STATE OF ARKANSAS
DEPARTMENT OF POLLUTION CONTROL AND ECOLOGY
8001 NATIONAL DRIVE, P.O. BOX 8913
LITTLE ROCK, ARKANSAS 72219-8913
PHONE: (501) 562-6533
FAX: (501) 562-2541

RE: Quarterly Progress Reports

RE: Conditional Approval of Workplan

Cedar Chemical Corporation
Conditional Approval
RFI Workplan
May 20, 1993

FIGURE 1-12
AOC #3
SAMPLING POINTS

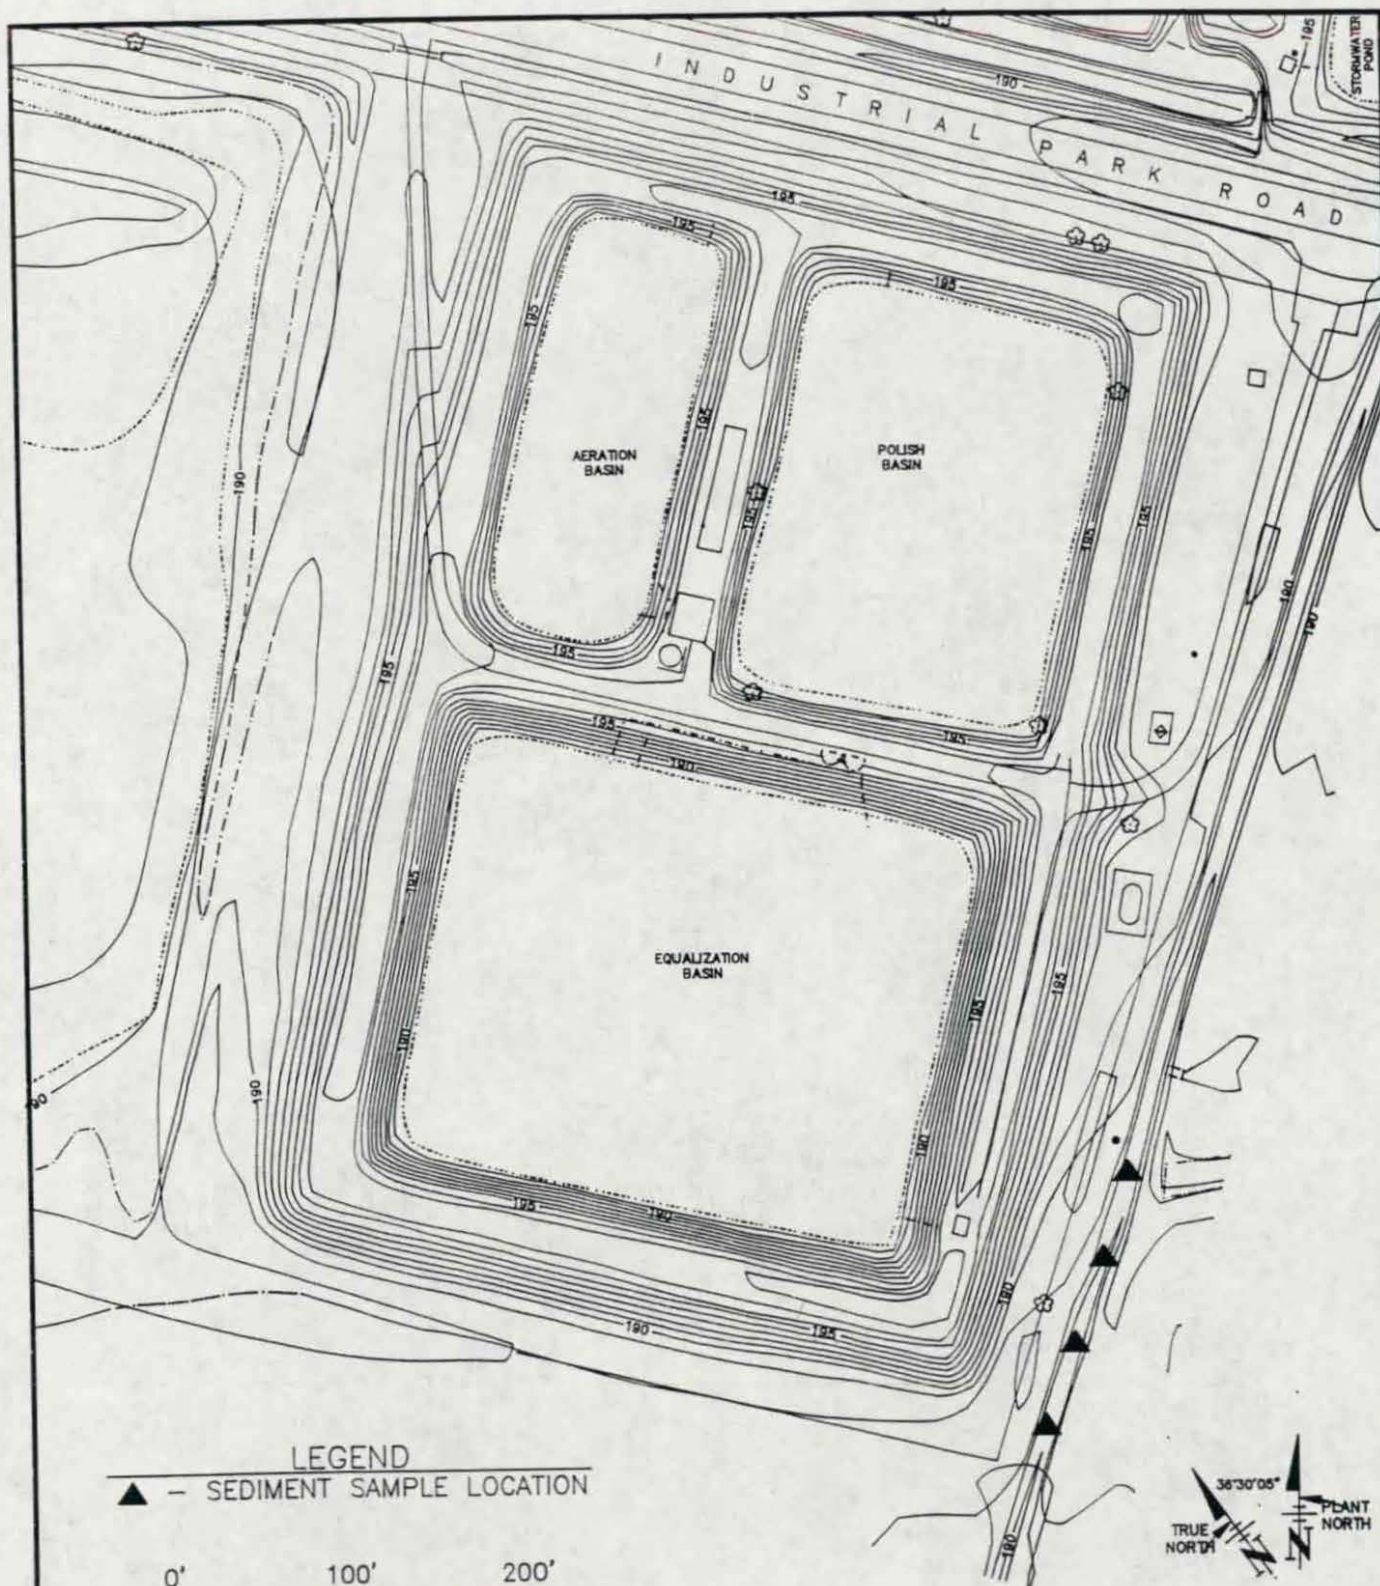
The samples collected as part of this Area of Concern investigation will also satisfy the soil/sediment sampling requirement for NPDES Outfall #001. A map showing the location of each sampling point can be found in Figure 1-12.
